07/02/2021 BID ADDENDUM #3 RKC DF REVISION

DIVISION OF ENGINEERING INFRASTRUCTURE REHABILITATION - PHASE 2 PLAYLAND PARK, RYE, NEW YORK

GENERAL DUCT BANK PLAN 1

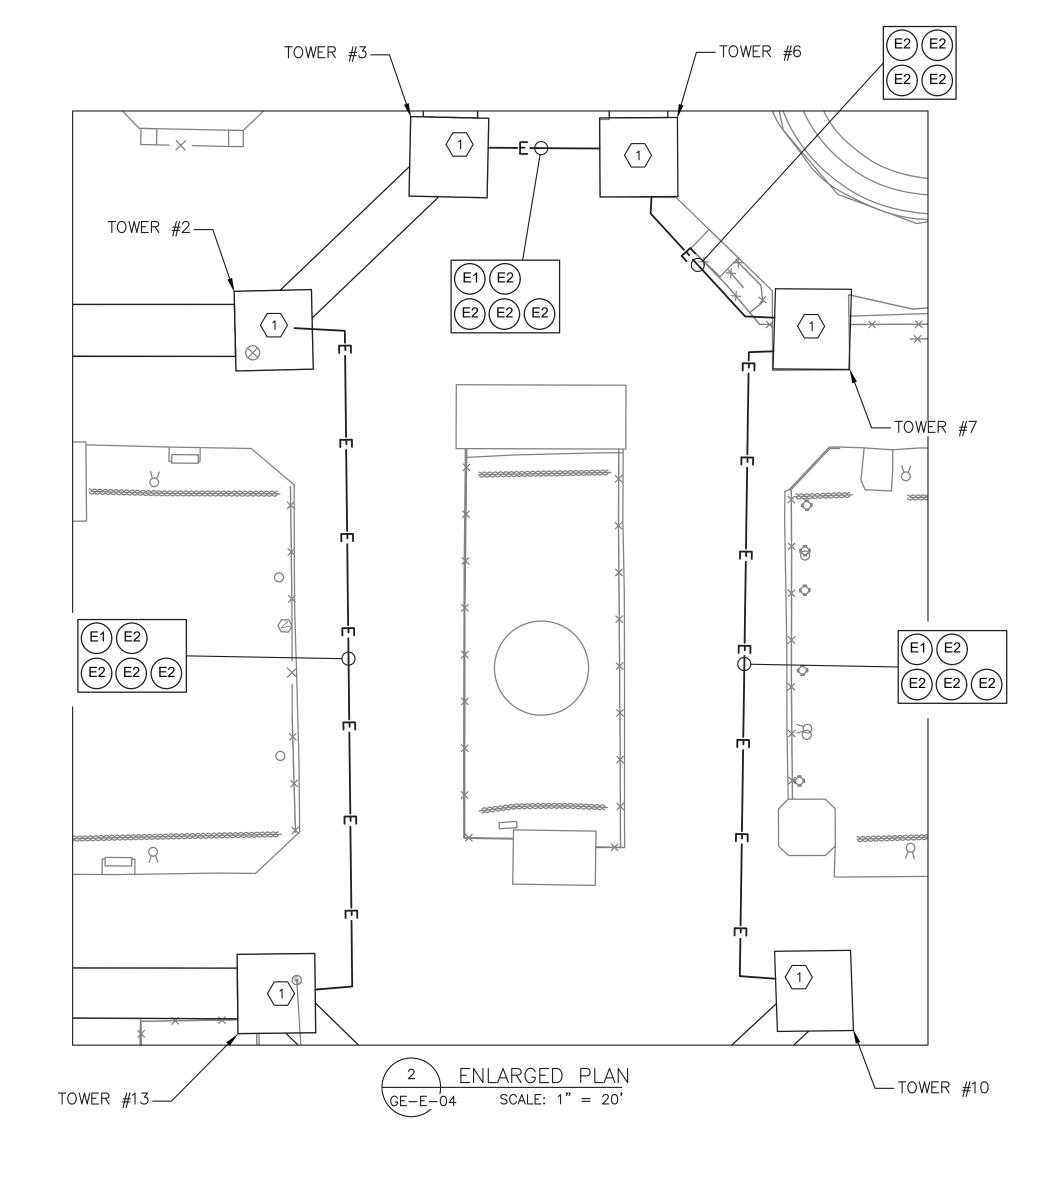
- $\langle 1 \rangle$ TOWER WILL HAVE NEW MANHOLE INSTALLED (SEE MAW-1 ADDENDUM STRUCTURAL DRAWINGS FOR ADDITIONAL INFORMATION). INCOMING UNDERGROUND CONDUIT WILL BE ROUTED TO NEW MANHOLE. CONTRACTOR IS ADVISED, UNDER THE MEGA 1 PROJECT, UNDERGROUND CONDUIT WILL BE INSTALLED AND CAPPED 8" PAST THE TOWER FOOTPRINT. MEGA 2 CONTRACTOR WILL INTERCEPT (AT THIS POINT) AND INSTALL NEW CONDUIT AS SHOWN.
- $\langle 2 \rangle$ PROVIDE 18" X 18" X 24" POLYMER CONCRETE HANDHOLE AT THIS LOCATION.
- (3) INCOMING UNDERGROUND CONDUIT SHALL BE ROUTED TO ATTIC SPACE OF STRUCTURE. CONCEAL EXPOSED CONDUIT AS MUCH AS PRACTICAL. STUB AND CAP CONDUIT FOR FUTURE USE.
